Service Bulletin

Bulletin No.: 03-06-04-005

Subject: Revised DTC P0230

Models: 1998-1999 Chevrolet Camaro
1998-1999 Pontiac Firebird
with 3.8L Engine (VIN K – RPO L36)

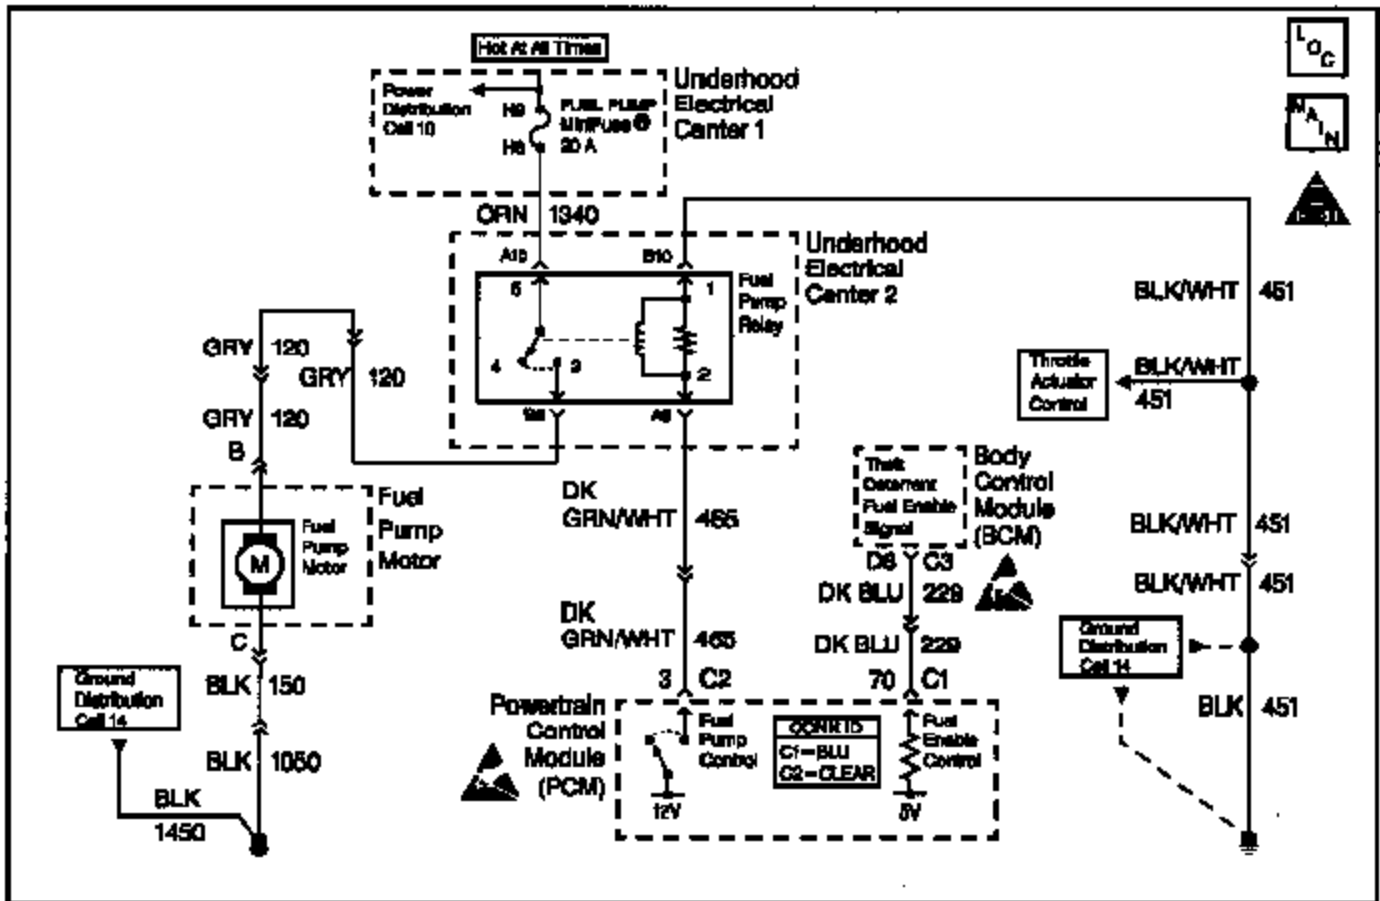
This bulletin is being issued to revise DTC P0230 in the Engine Controls-3.8L sub-section of the Service Manual. Please replace the current information in the Service Manual with the following information.

The correct schematic for the fuel pump relay control circuit is shown below.
